# SERVICE BULLETIN

Classification: RA17-004	Reference: NTB17-107	Date: September 26, 2017
-----------------------------	-------------------------	-----------------------------

## 2016-2017 MAXIMA AND ALTIMA; POP/CLUNK NOISE FROM REAR WHEN DRIVING OVER BUMPS

Figure 1

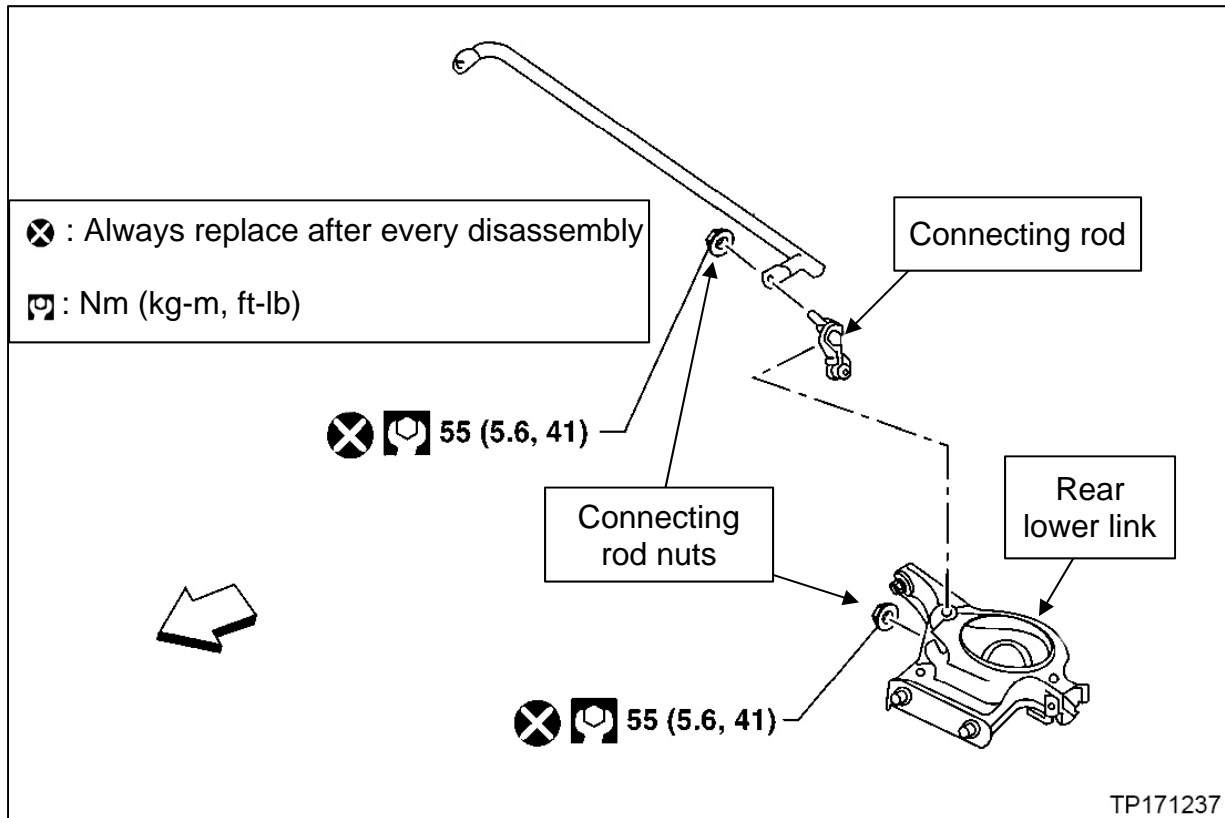
The rear suspension connecting rod nuts are found to be loose on the left and/or right side.

Replace the connecting rod and nuts on the left and/or right side with the ones listed in Parts Information.

1. Remove the connecting rod nuts on the affected side.
2. Remove the connecting rod.
3. Install the new connecting rod and nuts.
  - New connecting rods and nuts are listed in the Parts Information.
